APPLICATION NO.	FILING DATE	FIRST NAMED INVENTOR	ATTORNEY DOCKET NO.	CONFIRMATION NO.
10/821,188	04/09/2004	Bu-kil Jeong	1572.1338	8425
21171	7590	12/30/2005	EXAMINER	
STAAS & HALSEY LLP SUITE 700 1201 NEW YORK AVENUE, N.W. WASHINGTON, DC 20005			EARLY, MICHAEL JACOBY	
			ART UNIT	PAPER NUMBER
			3744

Office Action Summary

DETAILED ACTION

FIG. 1

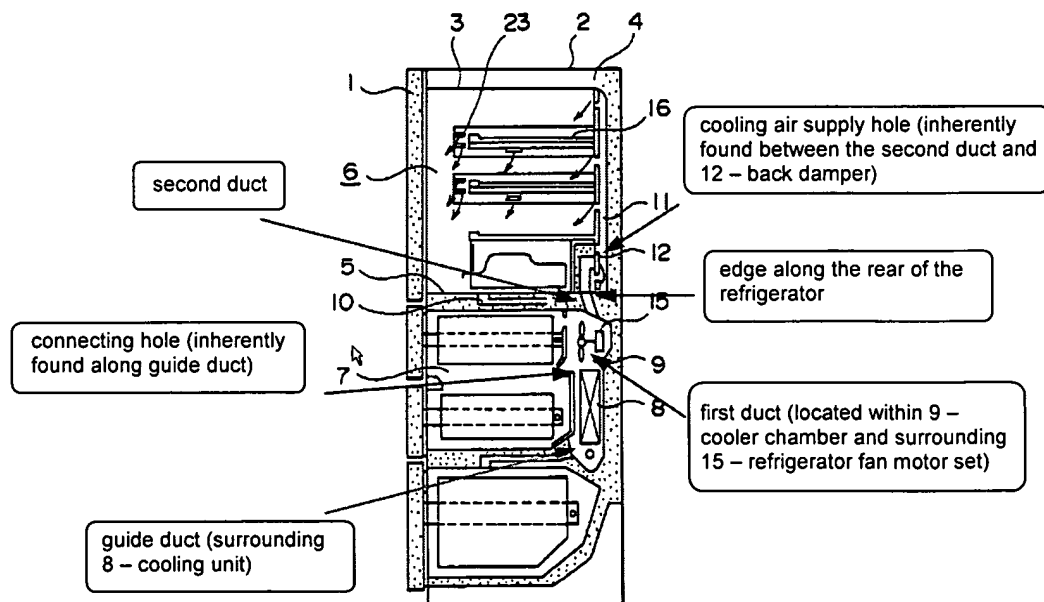
Claims 1 – 5, 7, 8, 10, 11, 13, 14, 18, 19, 21 and 22 are rejected under 35 U.S.C. 102(b) as being anticipated by Igari et al. (U.S. 6,044,654).

- a main body (the refrigeration unit as seen in Figures 1 and 2; col. 4, lines 1 – 3);
- a freezing compartment (7 – freezing chamber);
- a refrigerator compartment (6 – refrigerating chamber);
- a first duct (as seen in the diagram of Figure 1 below);
- a second duct that is provided around an edge of the rear of the refrigerating compartment (as seen in the diagram of Figure 1 below);
- a cooling air supply hole (the opening is inherently found between the 12 – back damper and second duct; as seen in the diagram of Figure 1 below);
- a main duct (11 – back cold-air channel);
- side ducts (18 – side cold-air supply duct) that are bar shaped and extend to a lower part of the refrigerating compartment (as seen in Figure 2);

FIG. 2

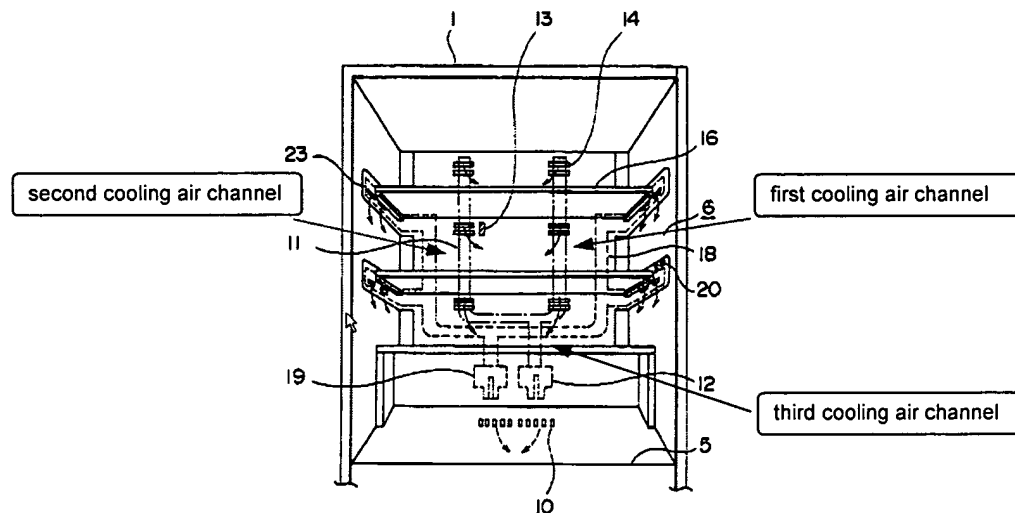
- side cooling air supply holes (23a, 23b, 23c – side blowoff ports);
- a damper (12 – back damper);
- a first cooling air channel (as seen in the diagram of Figure 2 below);
- a second cooling air channel (as seen in the diagram of Figure 2 below);
- a main cooling air supply hole (14 – back blowoff ports);
- a cooling air channel (inherently found within 11 – back cold-air channel; Figure 2);
- a third cooling air channel (as seen in the diagram of Figure 2 below);
- a guide duct (as seen in the diagram of Figure 1 below) that comprises a connecting hole (inherently found along the duct as seen in the diagram of Figure 1 below);
- a plurality of ducts (11 – back cold-air channel; 18 – side cold-air supply duct);
- cooling air supply holes (14 – back blowoff ports; 23a, 23b, 23c – side blowoff ports);
